## **4.0 RADIATION PROTECTION**

RAI 1-1-B-4, R2 PROPOSED

**Figure 9.2-2 Locations of American Centrifuge Plant Outfalls Discharging to Waters of the United States**

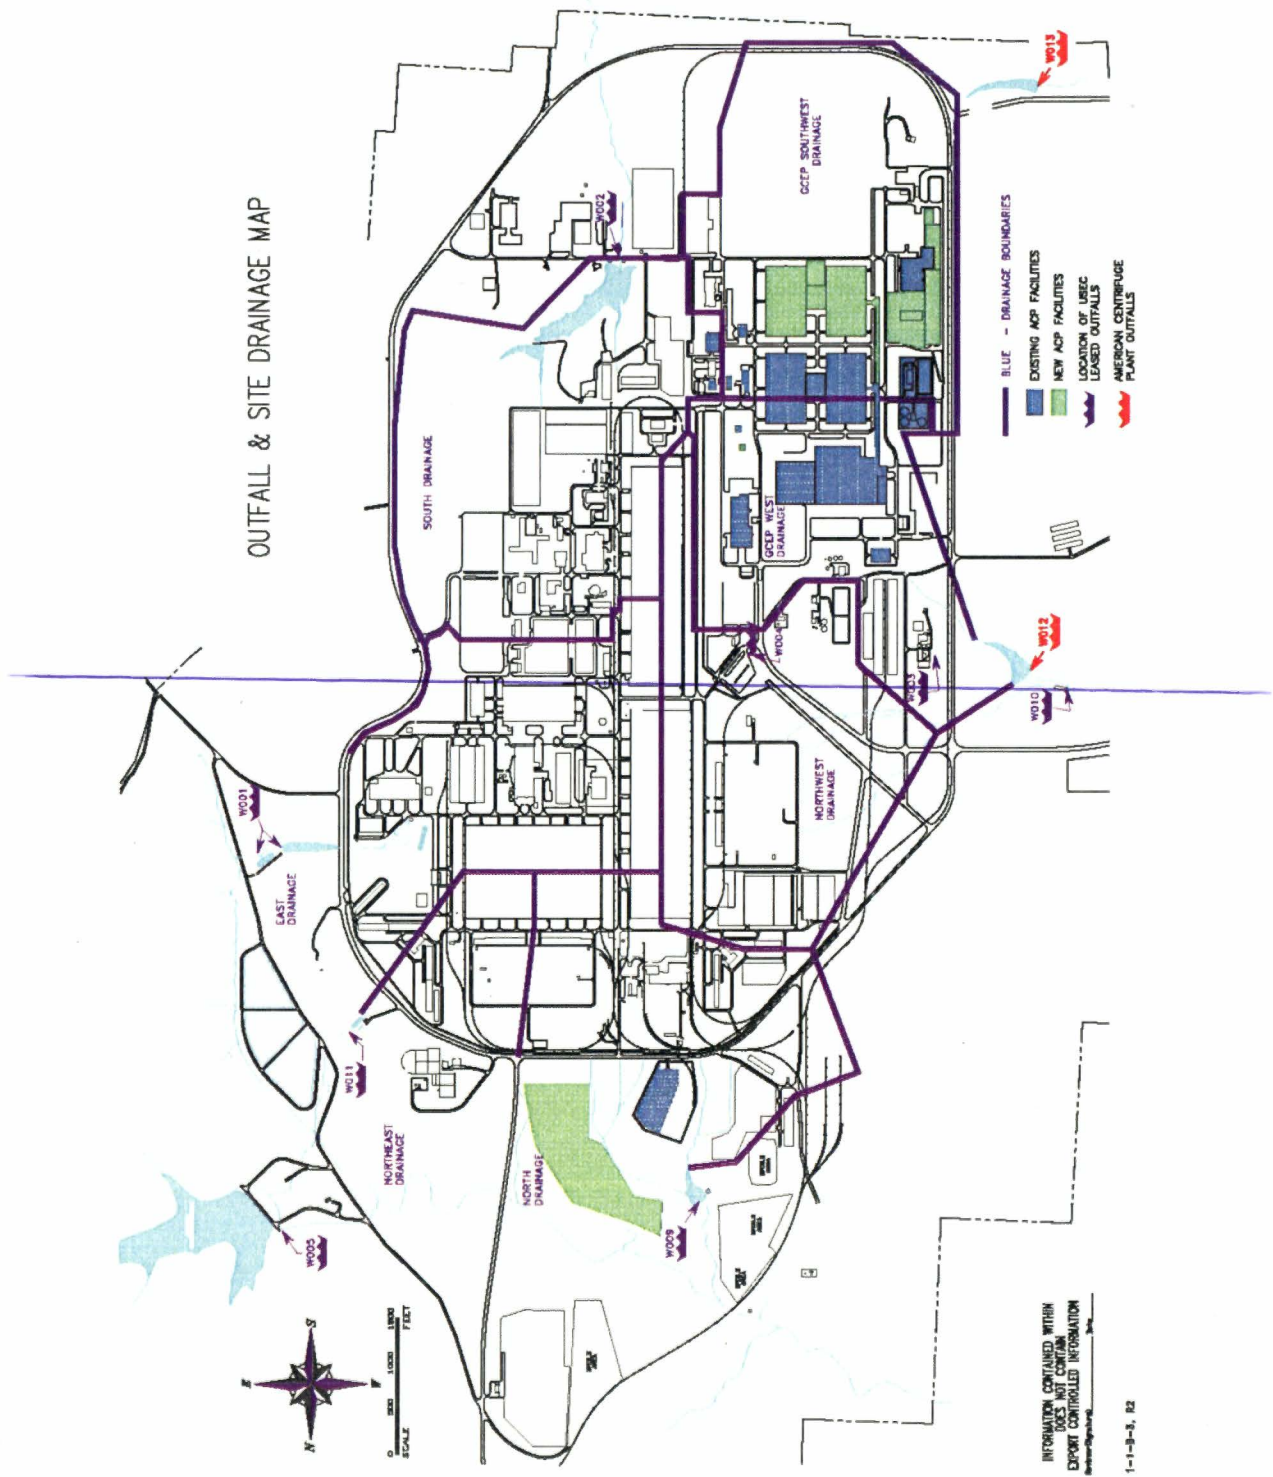
1-1-B-3, R3 PROPOSED
